November 14, 1975

RE: Indian Point Unit No. 2
Docket No. 50-247

MECHANICAL ENGINEERING BRANCH

REQUEST FOR ADDITIONAL INFORMATION

TABLE 1
IPP - MAXIMUM FORCES ACTING ON A REACTOR VESSEL SUPPORT

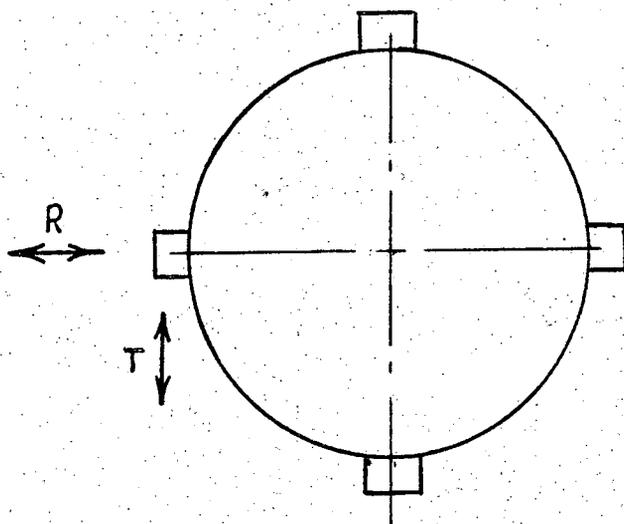
2. Specify the detail design loads used in the original design analyses of the reactor supports giving magnitude, direction of application and the basis for each load. Also provide the calculated maximum stress in each principal element of the support system and the corresponding allowable stresses.

The reactor vessel support system was sized using maximum combined load set cases of (1) 1,109 kips tangential, 322 kips radial and 1,329 kips vertical; (2) 613 kips tangential, 322 kips radial and 1,459 kips vertical; and (3) 1,006 kips tangential, 322 kips radial and 934 kips vertical. Each load set was applied to an individual support in the design phase. The loads applied in the analysis of the support system were derived from the criteria in the FSAR for Indian Point Unit No. 2.

Table 1 shows the maximum loads and combined loads derived from the application of this criteria to the reactor vessel supports. These loads are

applied in the analysis to each individual support. Since the applied lateral loads on the reactor vessel are resisted by two support shoes, the total lateral load applied to the reactor vessel is twice that applied to each shoe. The highest lateral load the reactor vessel will see given the above described design basis is 2,218 kips. The steam generator supports and the reactor coolant pump supports attached to the unbroken loops also resist the applied lateral loads. This effect which was conservatively not included, is significant as it will reduce the loads transferred to the vessel support, since the total loads would be redistributed to all the supports.

The concrete wall was designed to the requirements of the 1963 American Concrete Institute Code (ACI). For the applied loads in Table 1, the maximum bearing stress was determined to occur in the concrete under the ring girder. The calculated stresses at that location for combined seismic plus pipe loads were determined to be less than the ACI allowable stresses.

The ring girder was designed to the requirements of the 1963 American Institute of Steel Construction Code (AISC). For the applied loads in Table 1, the maximum stress is calculated to be less than the AISC allowable stress for non-normal loading conditions associated with plant emergency conditions. The extreme loadings of the pipe rupture are, therefore, below this stress limit used for the upset conditions.

The reactor vessel shoes were designed to the requirement of the AISC Code also. For the applied loads, the maximum stress was a shear stress in the pins between the shoe and the cooling plate/ring girder assembly. The shear stress in these pins is calculated to be less than the shear yield stress for the pins.
